Overview: The initial production release of the FTI-TLK1 harness has an issue where in some vehicles the secondary power input to the CN1 connector will overload the associated vehicle circuit, causing a fuse to blow. This issue affects the initial release of harnesses and is already being addressed in production. A field correction procedure is detailed below in Figure 1.

FTI-TLK1 Type 1A - Vehicle Coverage & Preparation Notes

FTI-TLK1 Type 1A - Installation Notes & Wiring Diagram

Figure 1: Step by step adapter correction

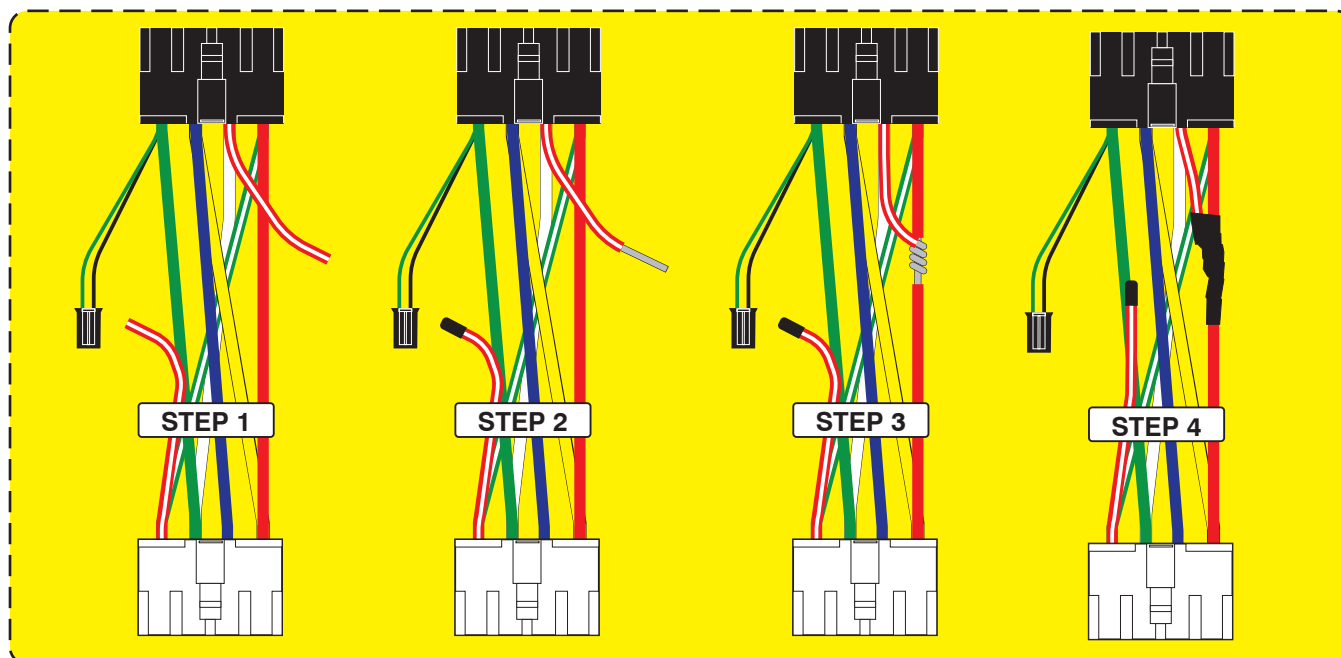
Issue: The secondary power circuit can overload some vehicle ignition switch circuits, causing a blown 5A/7.5A AM1 fuse, potentially disabling the vehicle and leaving the consumer stranded. Affected adapters are illustrated below in figure 2.

- 1.) Select the applicable CN1 adapter, isolate the RED/WHITE power wire, cut wire approximately 4" from the BLACK plug
- 2.) Insulate the wire still connected to the WHITE plug using heat shrink tubing, and strip the insulation on the other wire end
- 3.) Strip a portion of the insulation from the RED wire, attach the stripped RED/WHITE to the exposed RED wire, solder together
- 4.) Apply insulating tape to the soldered connection and secure the cut ends back to the bundle of wires created by the adapter
- 5.) Correction complete, you may safely proceed to finish your installation

Figure 2: Supplied CN1 Harness Adapters

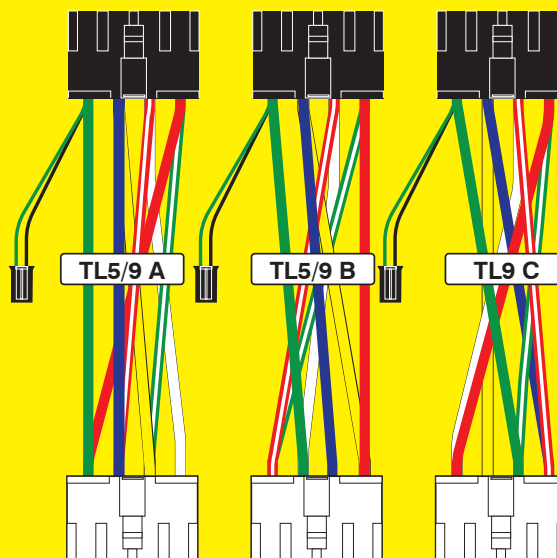
Incorrect power provisions with the potential to overload vehicle ignition supply circuit, resulting in blown AM1 fuse.
